#### SUPPLEMENTAL PACKET

CPTA20-0002 and DCA20-0002

#### **PUBLIC COMMENTS**

A Resolution recommending City Council amend the 2016 Transportation System Plan incorporating the 2021 Riverfront Addendum into the Newberg Comprehensive Plan and amending Newberg Municipal Code, Title 15, 15.050.030

Wynooski Parcel

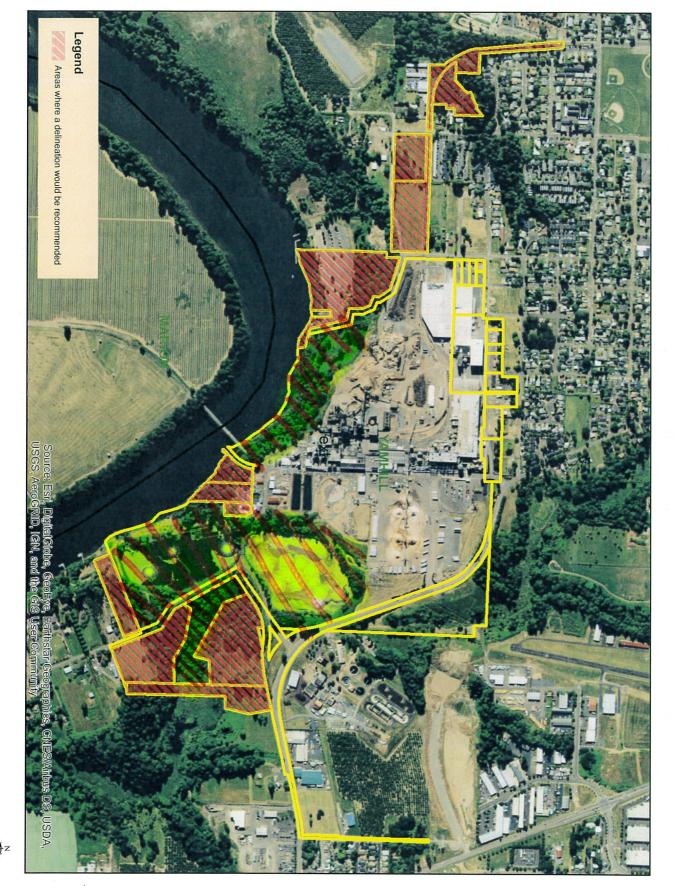
<u>Comments:</u> Based on a review of the available information, the aeration ponds were created within historic Hess Creek and would be considered jurisdictional by DSL if the ponds are unlined. A permit will be required for 50 cubic yards or greater of fill, removal or ground alteration within these ponds.

DSL recommends a wetland delineation for any project that impacts the aeriation ponds, or is located within areas that have not been currently developed (see attached map). Please note that the current Hess Creek channel and the Willamette River are Essential Salmonid Habitat. Any impacts within these waterbodies or their associated wetlands will require a permit. Additionally, Best Management Practices for sediment and erosion control are recommended for any work adjacent to these areas.
